MODIFICATION INSTRUCTIONS
for the
***Kodak X-Omat* MULTILOADER 300**
Service Code 3058
Modification No. 27

***Kodak X-Omat* 270 RA PROCESSOR**
Service Code 3059
Modification No. 18

- Purpose:**
- Install new style RACK SPRINGS that are more resistant to corrosion than the existing RACK SPRINGS.
 - Install new style Developer and Fixer replenishment FITTINGS to minimize chemical leakage from the current FITTINGS.
 - Install new style HEAT EXCHANGER FITTINGS to minimize leakage from the current HEAT EXCHANGER connections.
 - Install a new WASH TANK CLIP to increase the volume of water around the HEAT EXCHANGER in the WASH TANK to decrease false “Loss of Developer Cooling Ability” errors.

Installing the New SPRINGS in the CROSSOVERS

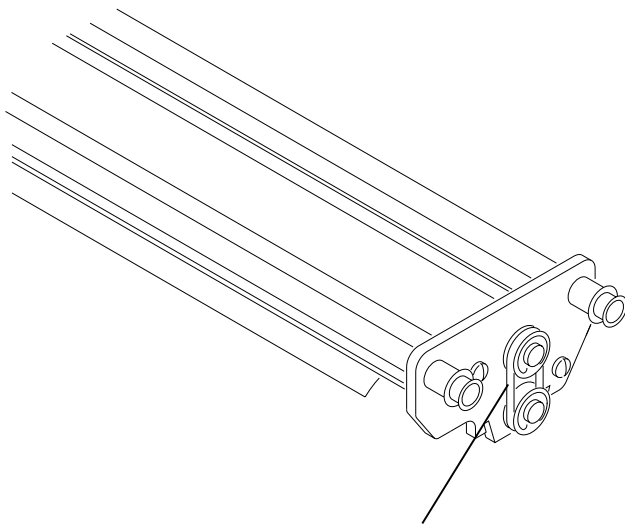
- [2] Remove and discard the 2 SPRINGS from the DEVELOPER/FIXER CROSSOVER and the FIXER/WASH CROSSOVER.
- [3] Install the 2 new SPRINGS, Part No. 1C7106, in both the DEVELOPER/FIXER CROSSOVER and the FIXER/WASH CROSSOVER.
- [4] Install the TROUGHS on the CROSSOVERS.

Installing the New SPRINGS in the WASH RACK

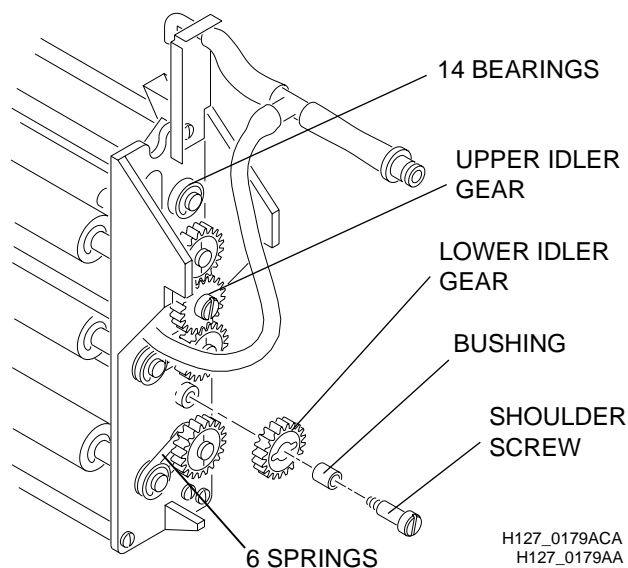
- [5] Remove from both the LOWER and UPPER IDLER GEARS on the WASH RACK:
 - SHOULDER SCREW
 - BUSHING
 - IDLER GEAR
- [6] Remove and discard the 6 SPRINGS from the WASH RACK
 - a. To remove the top SPRING on the non-drive side of the RACK, do the steps below.
 1. Remove the SPRING from around the BEARING.
 2. Place the SPRING between the teeth of the GEAR.
 3. Rotate the GEAR.
- [7] Install the 6 new SPRINGS, Part No. 1C7107.
- [8] Install the:
 - IDLER GEARS
 - BUSHINGS
 - SHOULDER SCREWS

Installing the new SPRINGS in the DRYER RACK

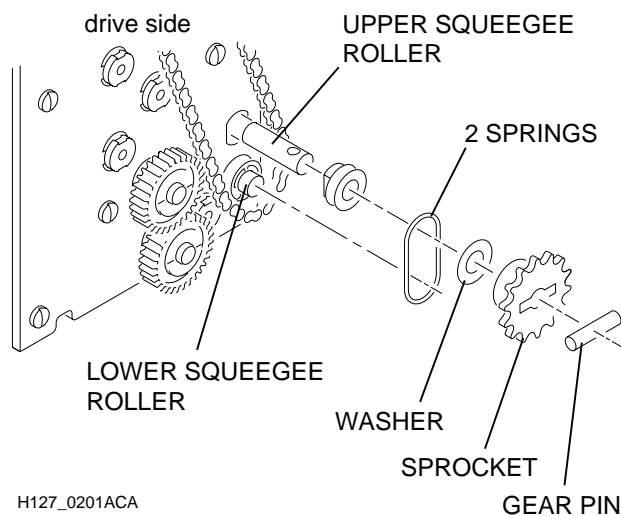
- [9] Remove the following parts from the UPPER SQUEEGEE ROLLER on the non-drive side of the DRYER RACK:
 - SPRING and discard
 - E-RING and keep
- [10] For access to the GEAR PIN, move the UPPER SQUEEGEE ROLLER toward the drive side of the PROCESSOR.
- [11] Remove from the drive side of the UPPER SQUEEGEE ROLLER:
 - GEAR PIN
 - SPROCKET
 - WASHER
 - SPRING and discard
- [12] Reverse Steps 9 through 11 to install the 2 new SPRINGS, Part No. 5B6165.

Section 4: Installing the New Replenishment FITTINGS

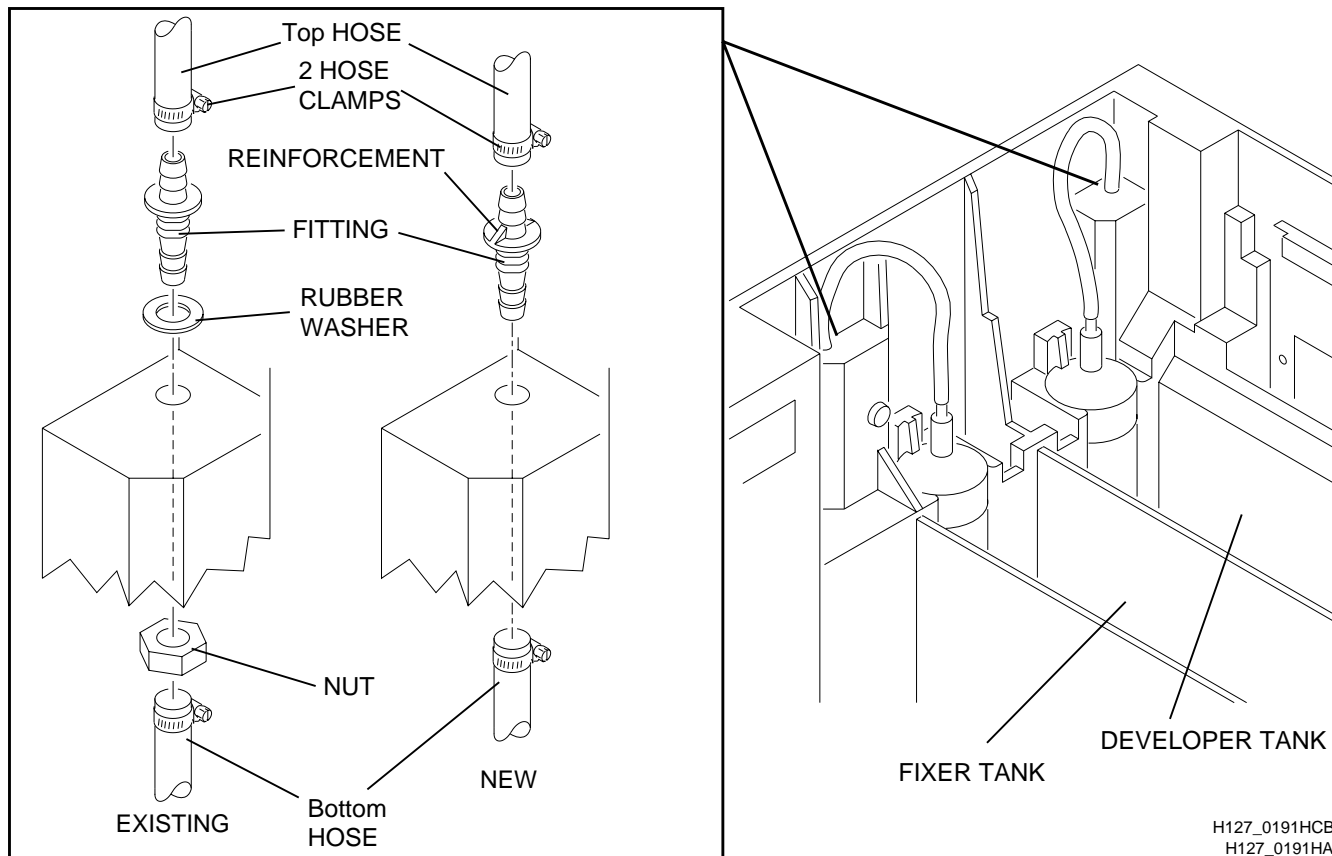
[1] Remove the existing FITTING, RUBBER WASHER, and NUT for the DEVELOPER and FIXER TANKS by doing the following for each FITTING:

[2] Install the new FITTINGS for the DEVELOPER and FIXER TANKS as follows:

- Install the FITTING between the top and bottom HOSE.
- Tighten the top and bottom HOSE CLAMPS to fasten the new FITTING.

Removing the Existing FITTINGS and FORMED TUBING

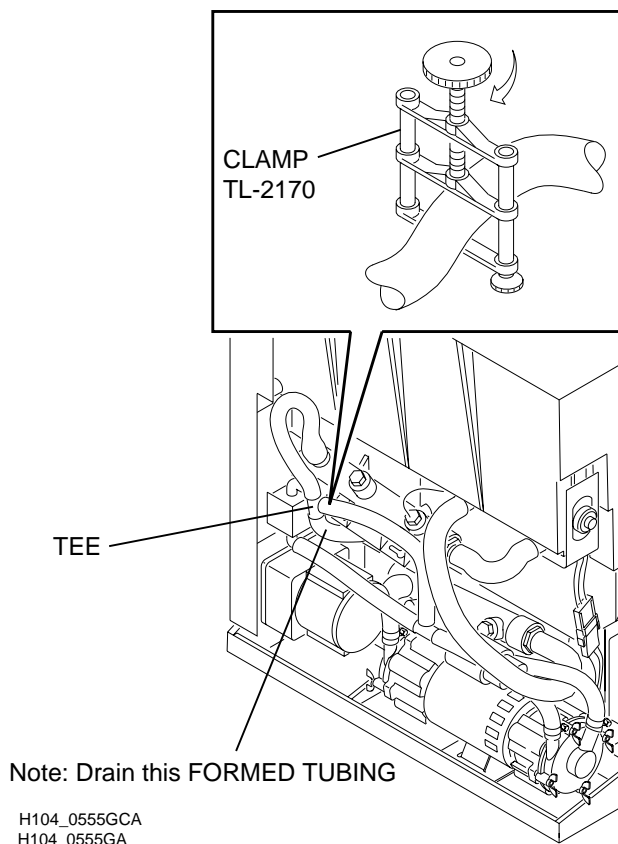
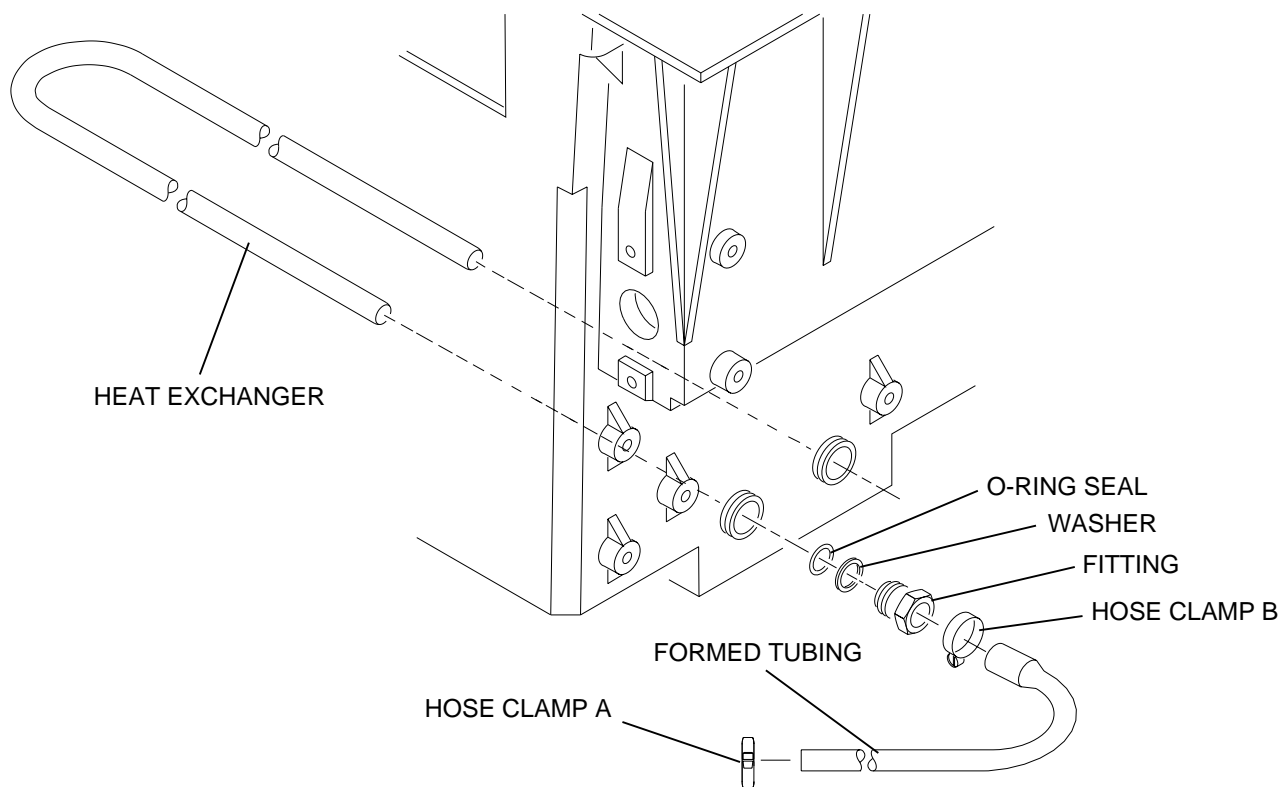
- (a) Install a CLAMP TL-2170 on each of the 3 FORMED TUBINGS connected to the TEE.
 - Install the CLAMPS TL-2170 close to the TEE.
- (b) Disconnect the FORMED TUBING, that requires draining, from the TEE. (See the figure above)
 - Keep the HOSE CLAMP A.
- (c) Loosen the HOSE CLAMP on the HEAT EXCHANGER end of the FORMED TUBING, and rotate the FORMED TUBING downward.
- (d) Remove the CLAMP TL-2170 and drain the FORMED TUBING into a container.

[3] Remove and discard:

Installing the New BARBED FITTINGS

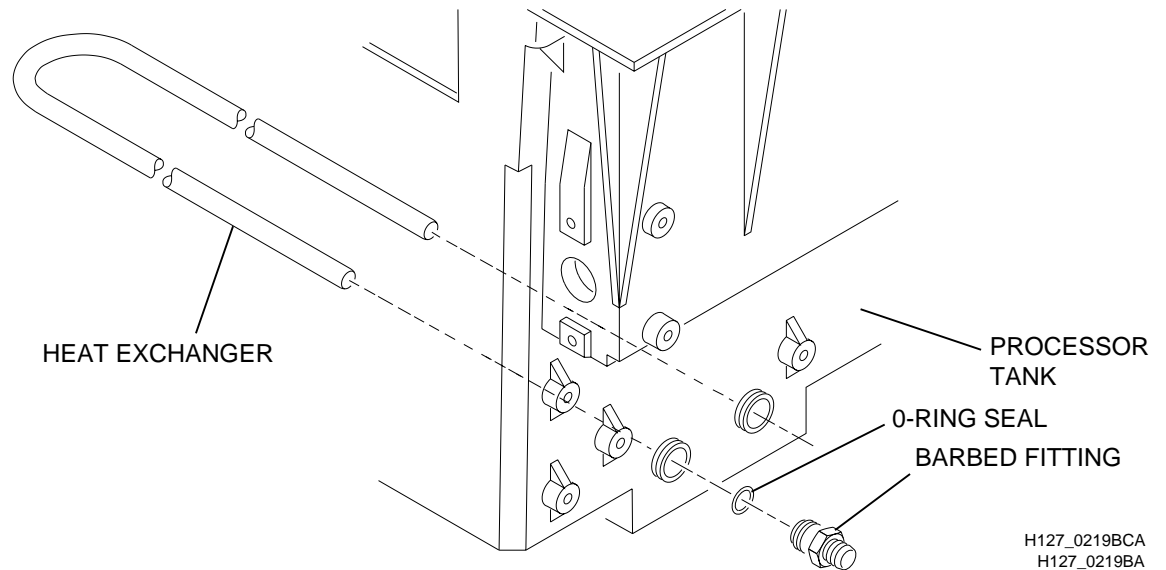
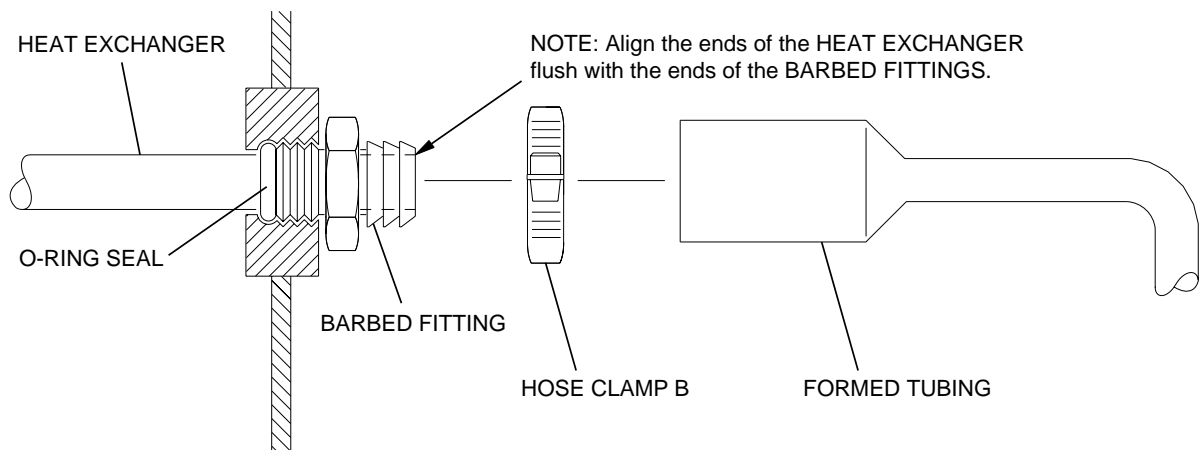
- [1] Place the ends of the HEAT EXCHANGER through the holes in the side of the PROCESSOR TANK.
- [2] Place a new O-RING SEAL on each end of the HEAT EXCHANGER.

DO NOT use the existing WASHERS with the new BARBED FITTINGS.

- [3] Place a new BARBED FITTING onto each end of the HEAT EXCHANGER.
- [4] Loosely rotate the new BARBED FITTINGS into the holes in the side of the PROCESSOR TANK.

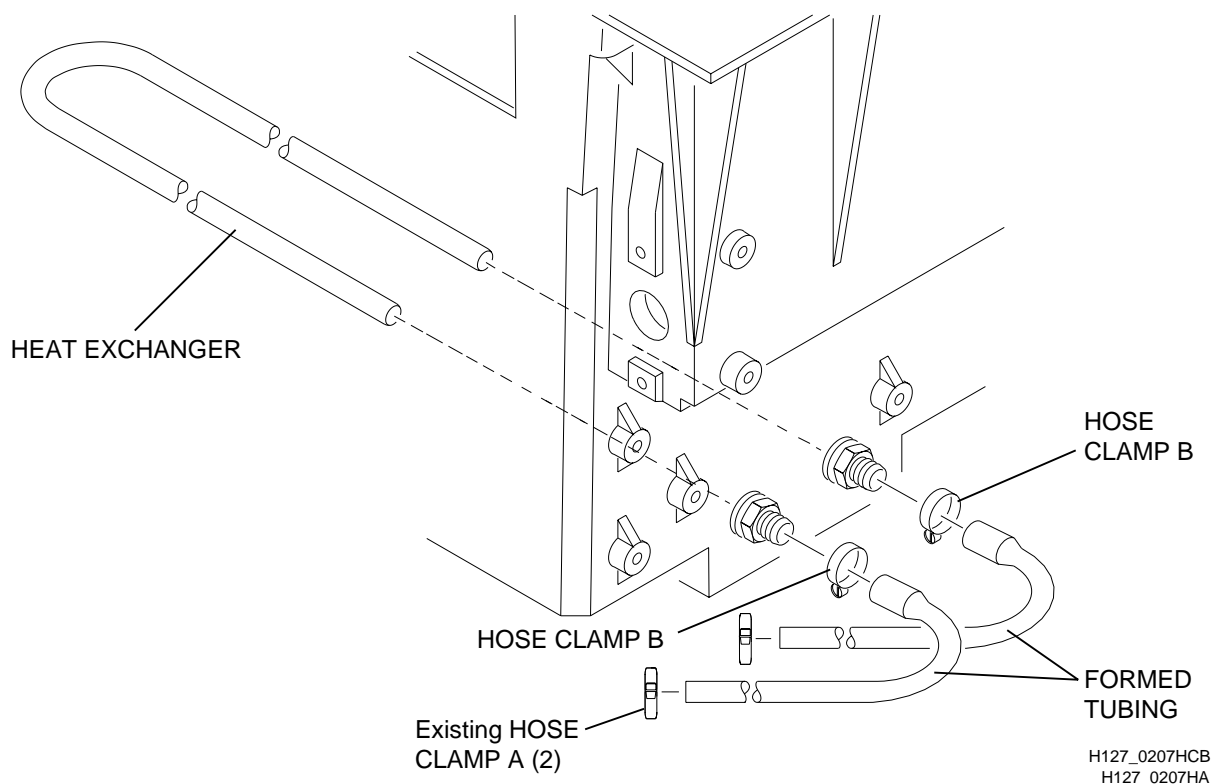
Do not tighten the BARBED FITTINGS more than necessary to correctly seat the O-RING SEALS. Incorrect installation of the BARBED FITTINGS will cause damage to the O-RING SEALS and fluid leakage.

- [5] Align the ends of the HEAT EXCHANGER flush with the ends of the BARBED FITTINGS and tighten the BARBED FITTINGS.

Section 6: Installing the New WASH TANK CLIP

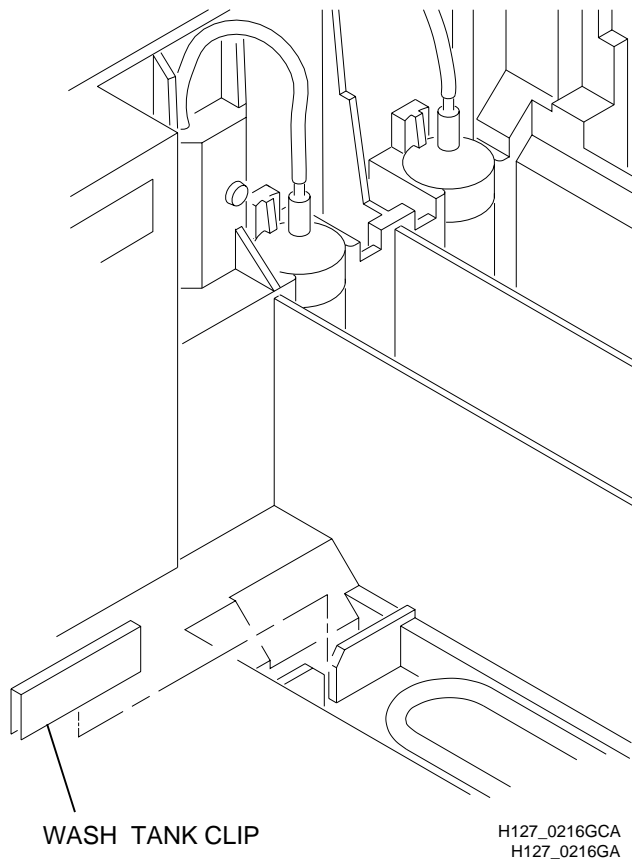
- [1] Remove and discard the existing WASH TANK CLIP.
- [2] Install the new WASH TANK CLIP.
